P&Z CASE # SP2021-018 P&Z DATE 07/13/21 CC DATE _____ APPROVED/DENIED _____

PROJECT NUMBER: SP2021-018
PROJECT NAME: Site Plan for Lakeshore Office Building
SITE ADDRESS/LOCATIONS: 1942 N LAKESHORE DR

06/25/2021: SP2021-018; Site Plan for a Lots 2 & 4, Block A, North Lake Shore Daycare Addition
Please address the following comments (M= Mandatory Comments; I = Informational Comments)

LANDSCAPE PLAN
LAKESHORE MEDICAL
1942-1944 N. LAKESHORE DRIVE
CITY OF ROCKWALL
ROCKWALL COUNTY, TEXAS

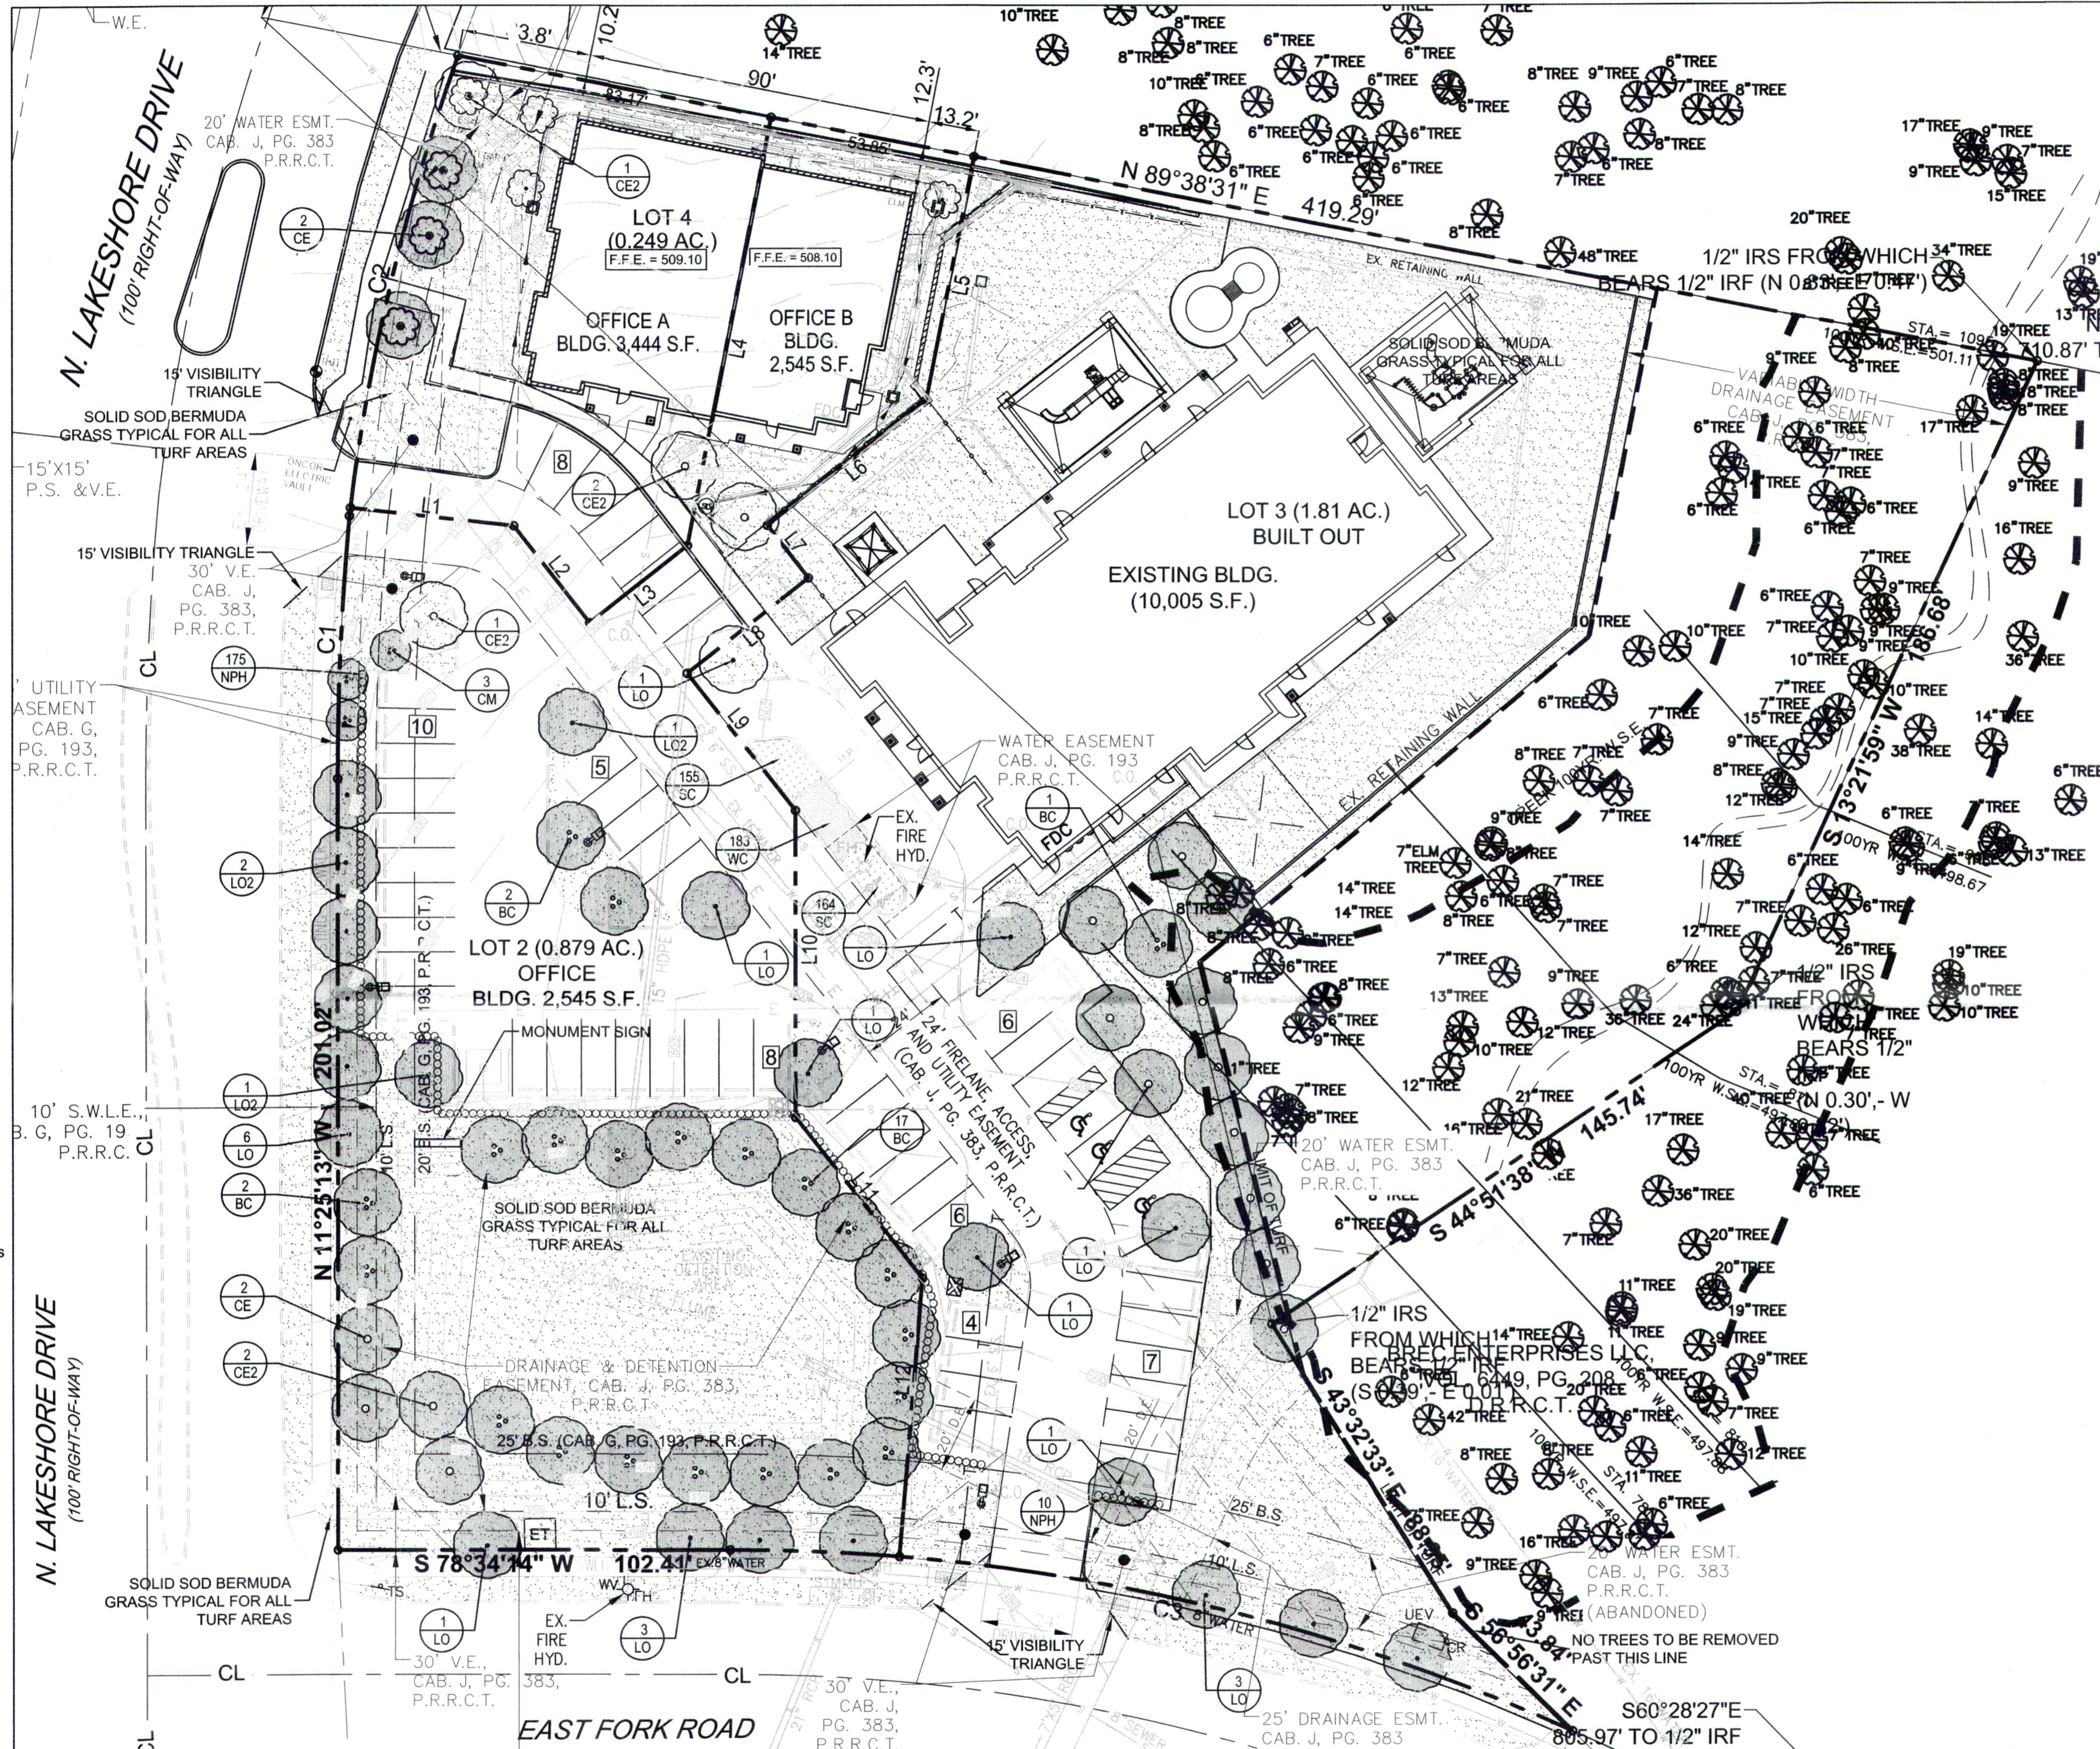
M.10 Landscape Plan. Please make the following clarifications and changes to the landscape plan to ensure staff can properly review this project and convey all of the required elements to the City's boards and commissions (§01.02, Art. 11, UDC):

- 1) Canopy trees are required to be a minimum of four (4) caliper inch at DBH. Correct plans. (§06.02.E.2, Art. 05, UDC)
- 2) Clarify the statement under Plant Material Schedule "(4) 5" caliper cedar elm trees that were planted...tree location and specifications" and indicate on plans which trees were removed and the proposed location of where these trees are to be planted. (Section 05 and Section 06, Art. 09, UDC)

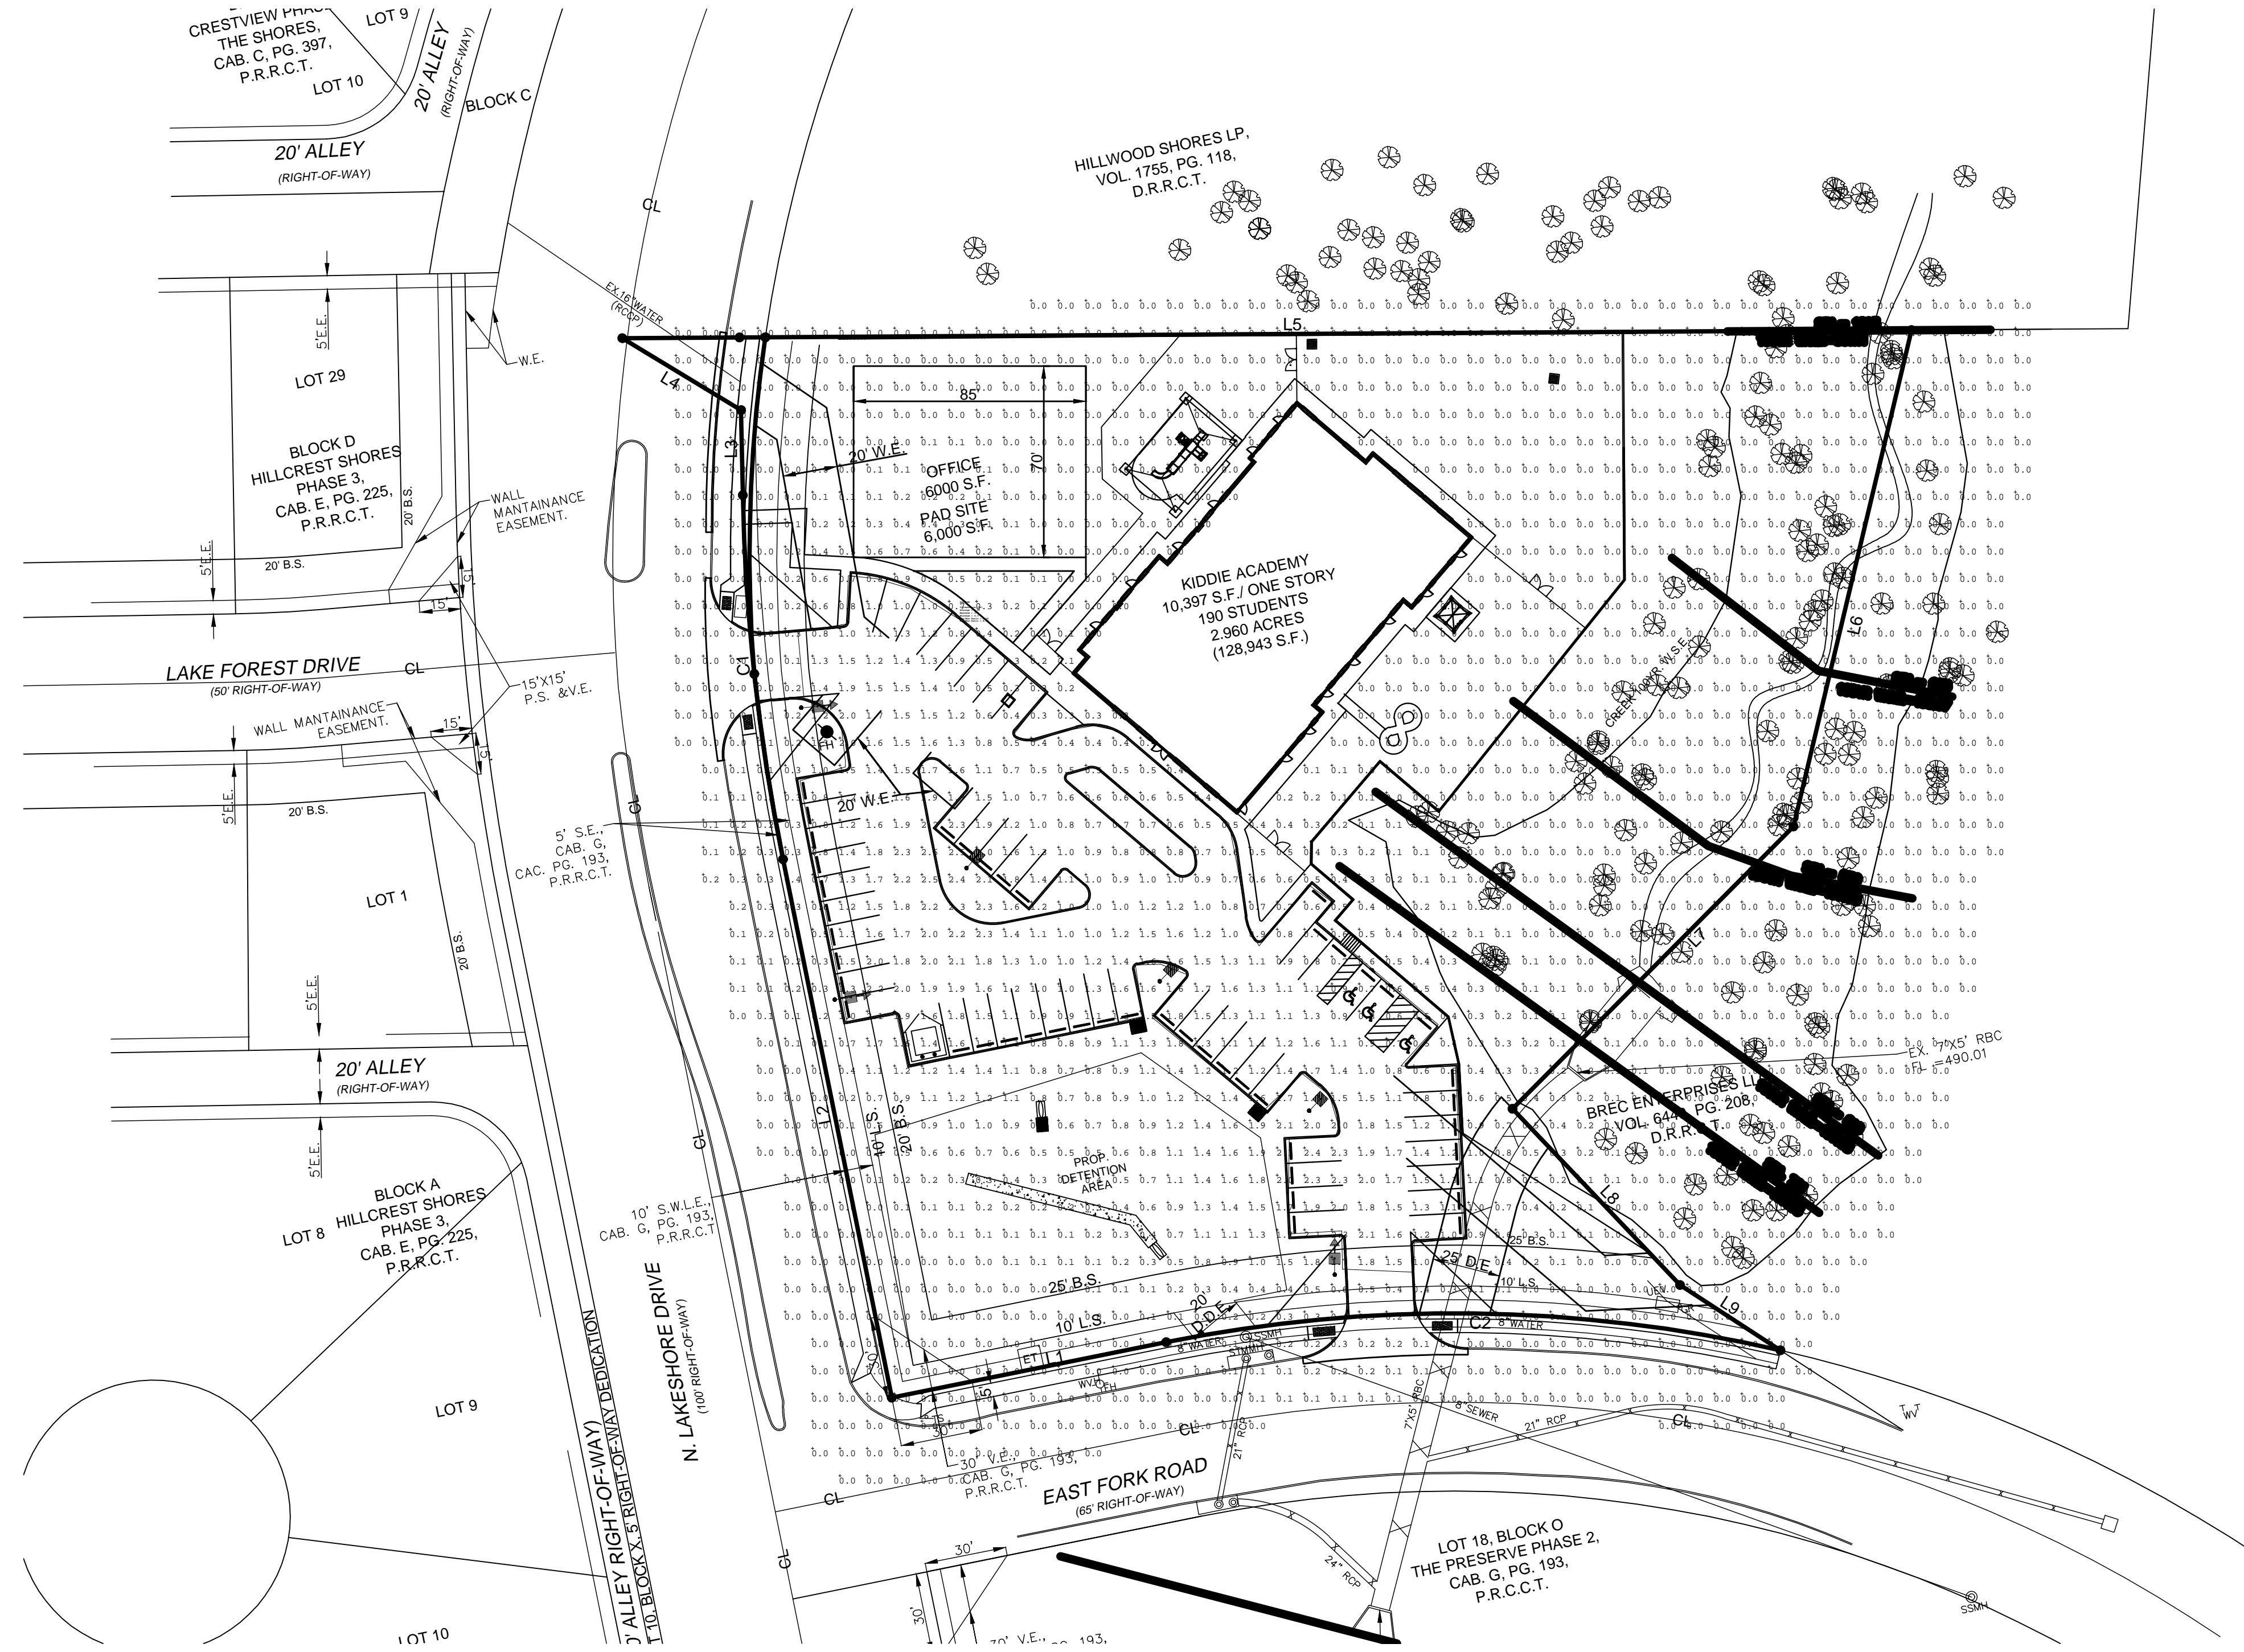
M.12 Photometric Plan. Please make the following clarifications and changes to the photometric plan to ensure staff can properly review this project and convey all of the required elements to the City's boards and commissions (§01.02, Art. 11, UDC):
